PLANNING BOARD AGENDA
CONDUCTED WITH ZOOM
DECEMBER 01, 2020 7:00 PM – TUESDAY

Re: Boro File No. MSPB-R1320
Variance – Weaver – *Revised Review*
Block 169.05, Lot 61
131 Third Avenue
R-3 Single-Family Residential Zone
Borough of Manasquan, Monmouth County, NJ

Re: Boro File No. MSPB-R1140
Use Variance and Site Plan – Vasilenko
Block 62, Lot 13
43 Taylor Avenue
O - Office Zone
Borough of Manasquan, Monmouth County, NJ

PLOT PLAN
131 THIRD AVENUE
BLOCK 169.05 - LOT 61
FOR CINTHIA WEAVER

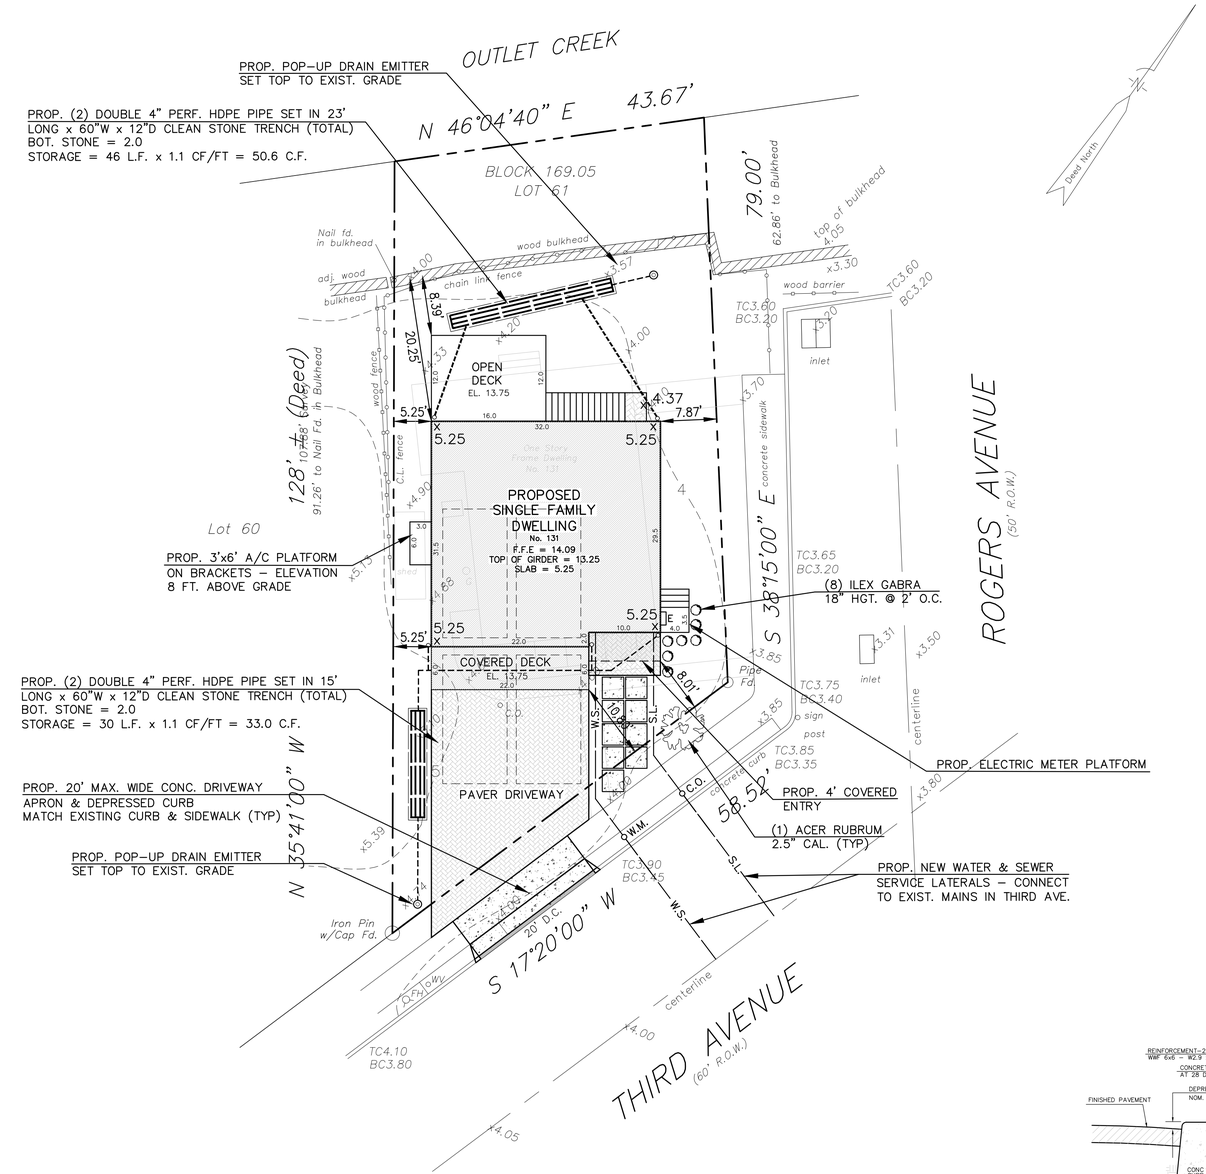
a. A minimum front yard setback of 25 feet is required, whereas a setback of 8.01 feet is proposed (10.10 feet exists).

b. A minimum rear yard setback of 20 feet is required, whereas a setback of 8.39 feet is proposed to the rear deck.

c. A minimum side yard setback (corner lot) of 7 feet is required, whereas a setback of 5.07 feet is proposed to the raised electric meter platform and 4.71 feet to the generator platform.

d. Mechanical equipment is not permitted within the side yard setback whereas the raised air conditioning units and generator are proposed within the side yard (corner) setback.

4. The proposed first floor elevation of the dwelling at 14.09 feet where the current base flood elevation is 10 feet.

5. Addressed. A stormwater management system has been provided on the plan. Test pit data which shows the seasonal high water table elevation must be submitted.

16. A street excavation permit will be required for the new apron and depressed curb on Third Avenue.

1 ASP1.0 CONCEPT ARCH SITE PLAN
SCALE: 1" = 10'-0"

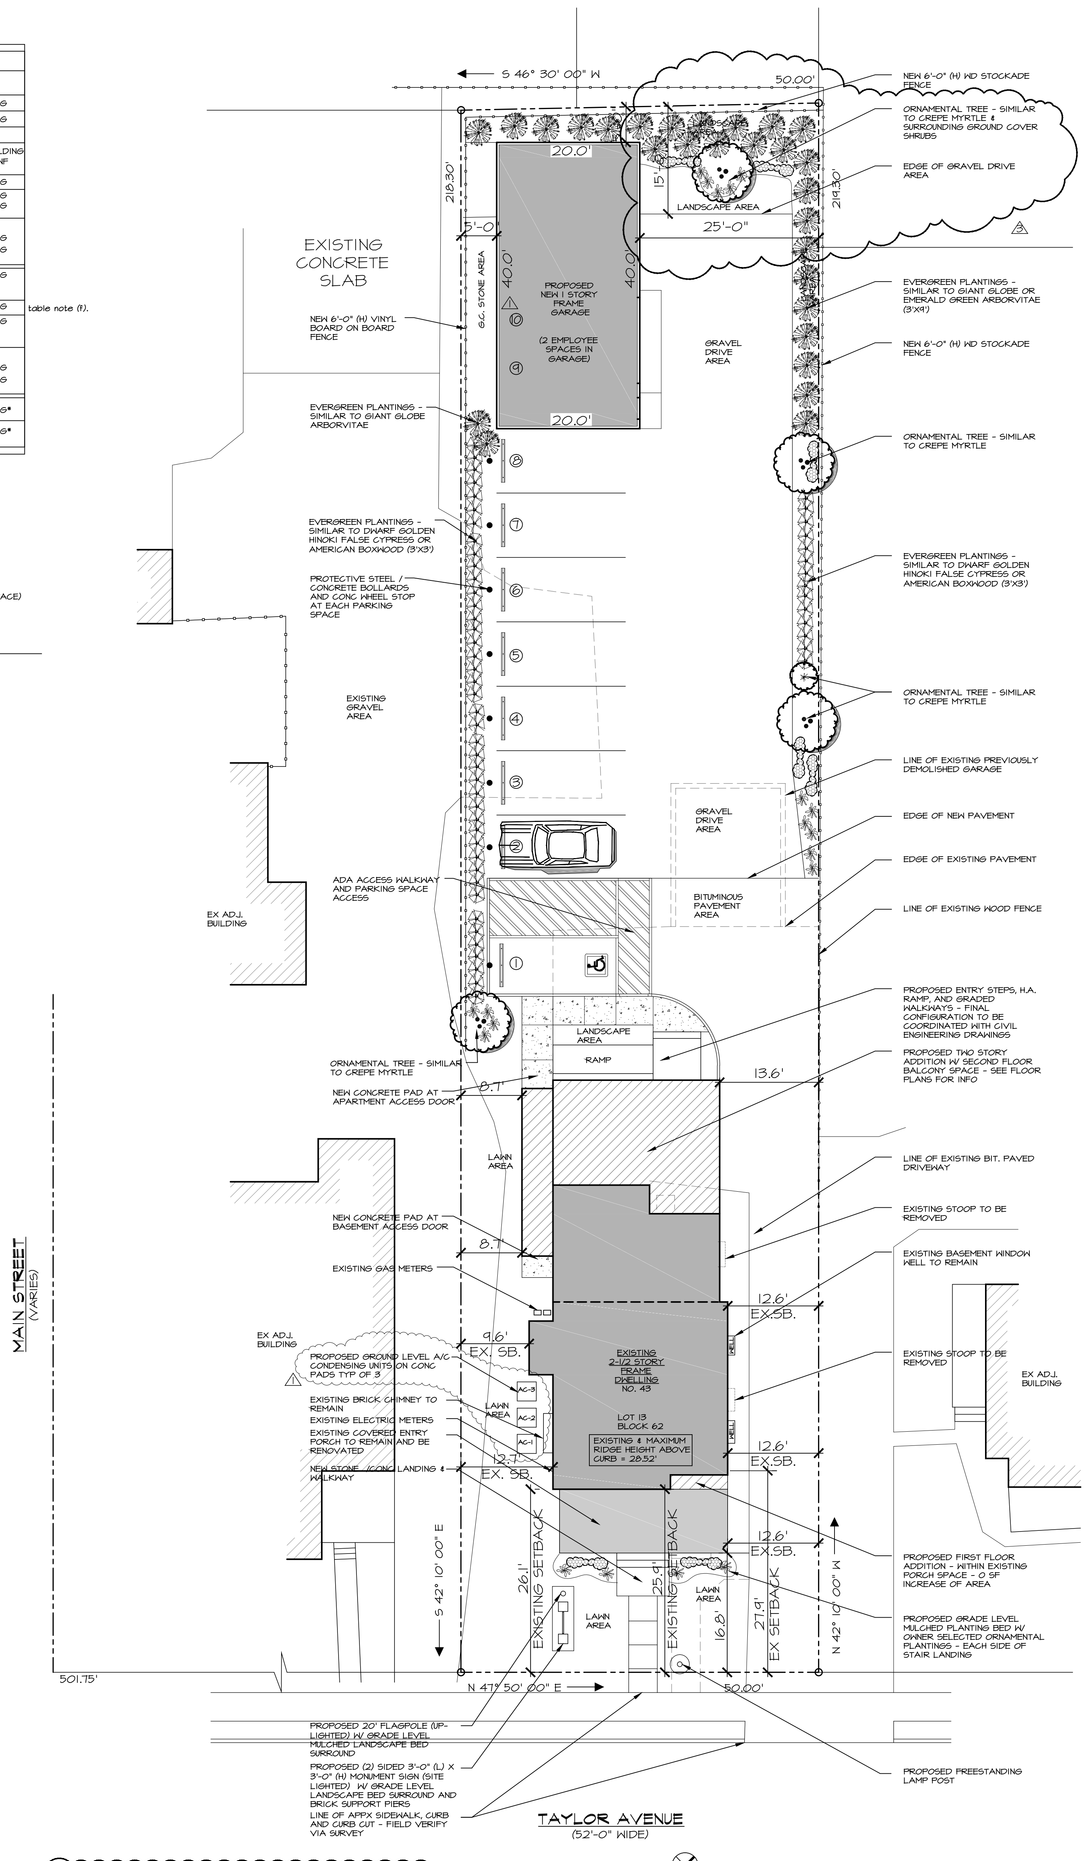
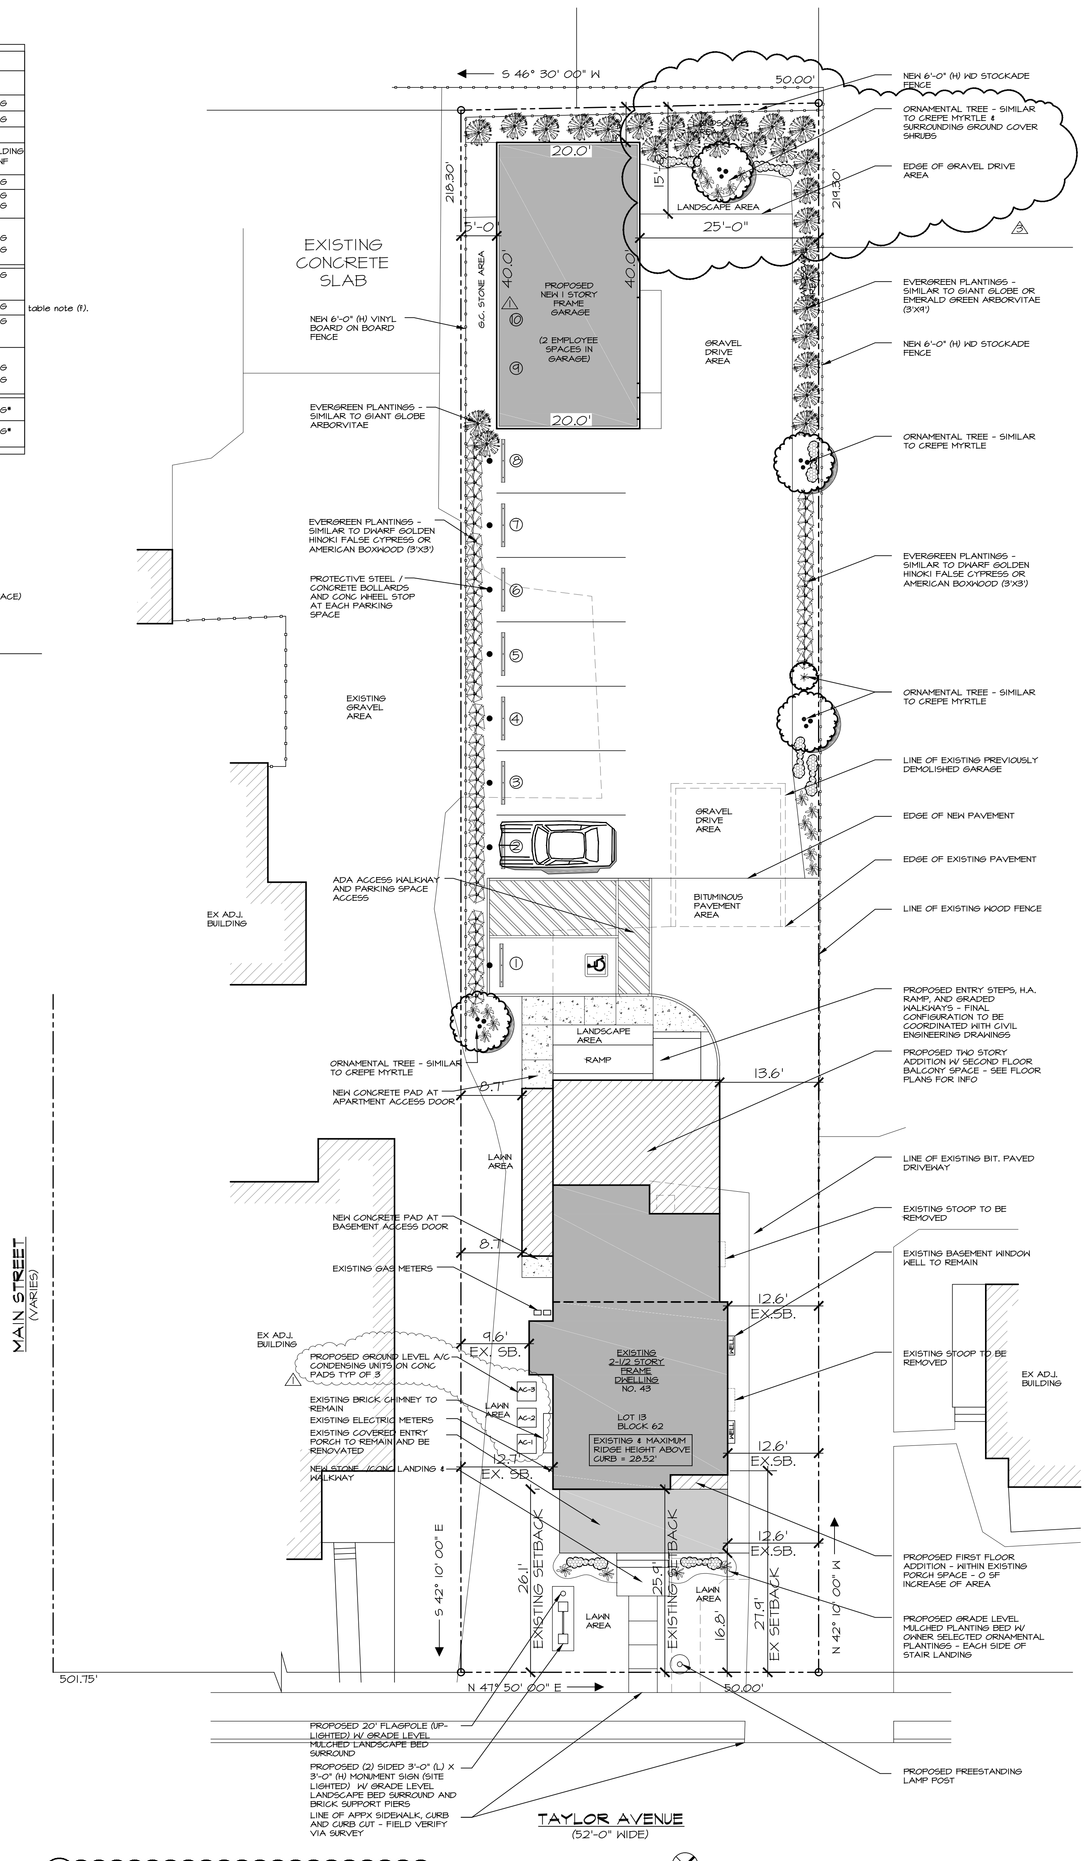
6. The continued use of the shared driveway with adjacent Lot 14 should be discussed with the Board. If an easement exists, it should be shown on the plan. Also, the repaving of the driveway will need appropriate milling so as to not change the elevation an affect the adjacent property and driveway.

9. The drainage report states that there are drywells to address stormwater runoff from the proposed detached garage. The location of the drywells must be provided on the plans as well as sizing calculations.

13. A revised landscaping plan should be submitted as the landscaping plan on the architectural layout does not match the current site plan.

16. Any building mounted lighting or parking lot lighting must be shown on the plan. Also, the flag pole and lamppost should be shielded to prevent glare to adjacent properties.

1 G1.0 GARAGE FOUNDATION PLAN
SCALE: 1/4" = 1'-0"

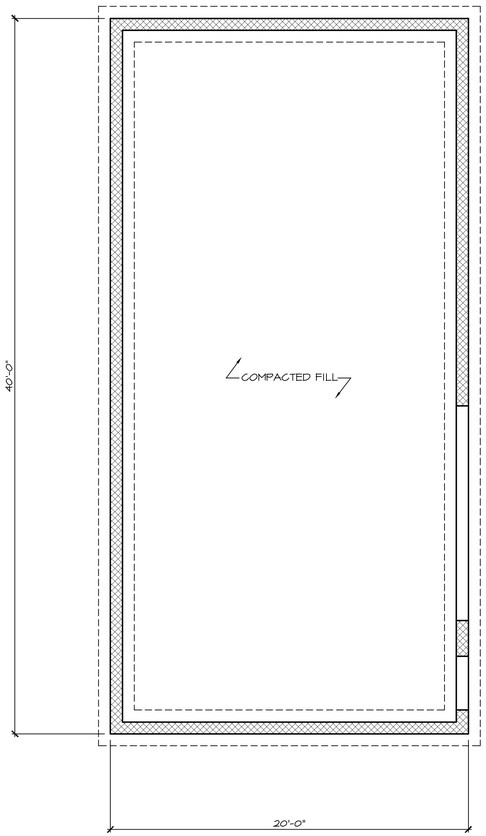
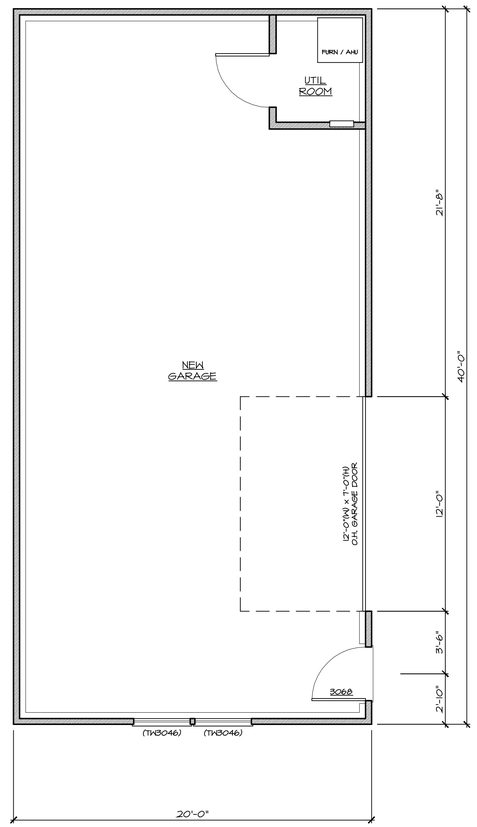
14. The architectural layout for the garage may need to be revised as the doors and windows do not seem to correspond to the current layout. Also, any concrete entry landings for the door or garage door should be shown on the site plan.
